TECH ADVISORY

TORQUE CONVERTER

JUNE, 2007

Standard Length Studs (.650") for All Ford Billet Front Covers

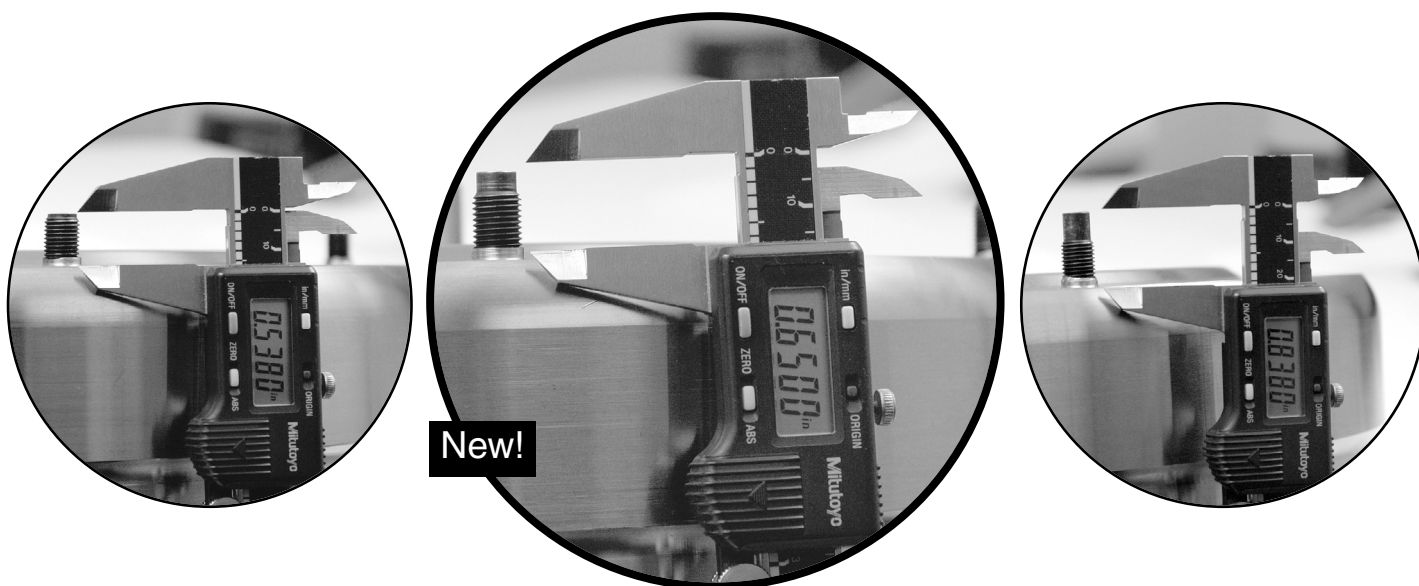
Sonnax will be standardizing the stud length on all Ford billet front covers. Some part numbers will be changed slightly as referenced below. Pictured below are details showing the earlier short stud (.538"), long stud (.838") and the new, universal length stud (.650"). These universal stud length covers can be used in both gas and diesel applications.

PART NUMBER	DESCRIPTION
FD-CC-11	E4OD 6-Stud (Replaces FD-CC-11S)
FD-CC-12	E4OD 4-Stud (Replaces FD-CC-12D and FD-CC-12G)
FD-CC-17S	E4OD, 4R100 Grob, 6-Stud
FD-CC-17L4	E4OD, 4R100 Grob, 4-Stud
FD-CC-19R	AODE, 4R70W, 12", Reaction Surface Finish, 4-Stud
FD-CC-20R	AODE, 4R70W, 11-1/4", Reaction Surface Finish, 4-Stud
FD-CC-21S	5R110W, Grob, 6-Stud
